*Proceedings of the Madras Government, Revenue Department,  
5th March 1869.*

*Treasure vaults in Bellary Talook Cut-cherries.*—Board of Revenue to furnish explanation with reference to certain deviations from the standard plan.

**Bellary District.**

Plan and Sections of a Treasure vault for the  
Taliq Catchery at Kocvinhudgully, District Bellary

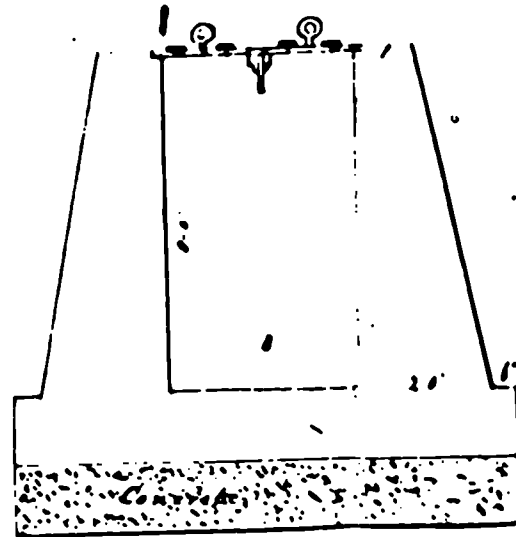
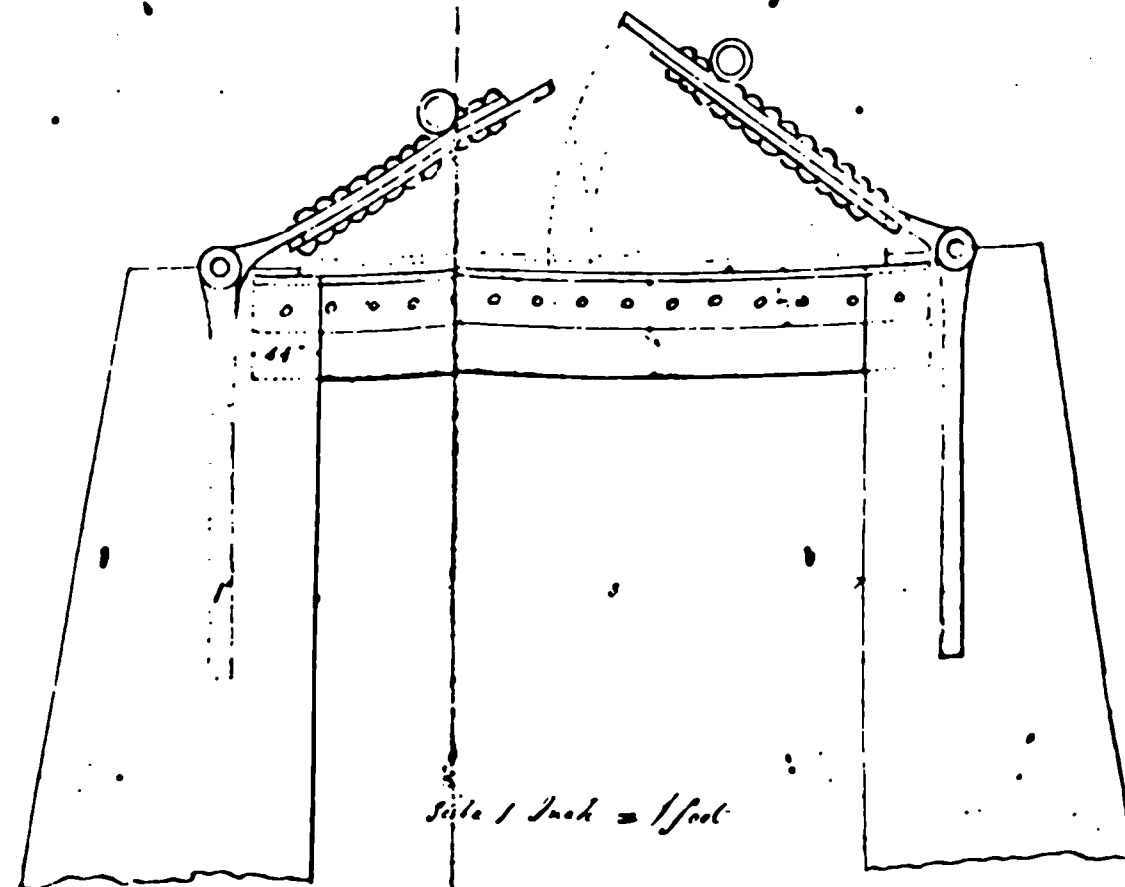
No. 2,508, the vault is to be lined with cut stone, with a clear space inside, of feet 11-9 long by feet 5-9 wide and feet 6 deep; but the specifications now submitted provide for only 3×3×5 for each of the vaults, and the side walls and floor of that in the Talook Cutcherry at Hospett is to consist of brick-in-chunam. The Board of Revenue will be requested to furnish an explanation for this deviation from the instructions contained in the Orders alluded to.

According to the  
standing order No. 987, bearing  
the Order of Govt. dated  
Sept. 1866, No. 2508, the vault  
is to be lined with cut stone  
with a clear space inside,  
feet 11-9 long by feet 5-9  
and feet 6 deep, but the  
specifications now submitted  
vide for only 3x3x5 for  
of the vaults, and the side  
and floor of that in the  
look Cutcher at Th  
is to consist of brick m  
churnam. The Board

Mr. [unclear] will be requested to  
furnish an explanation for  
this deviation from the practice  
contained in the orders  
alluded to.
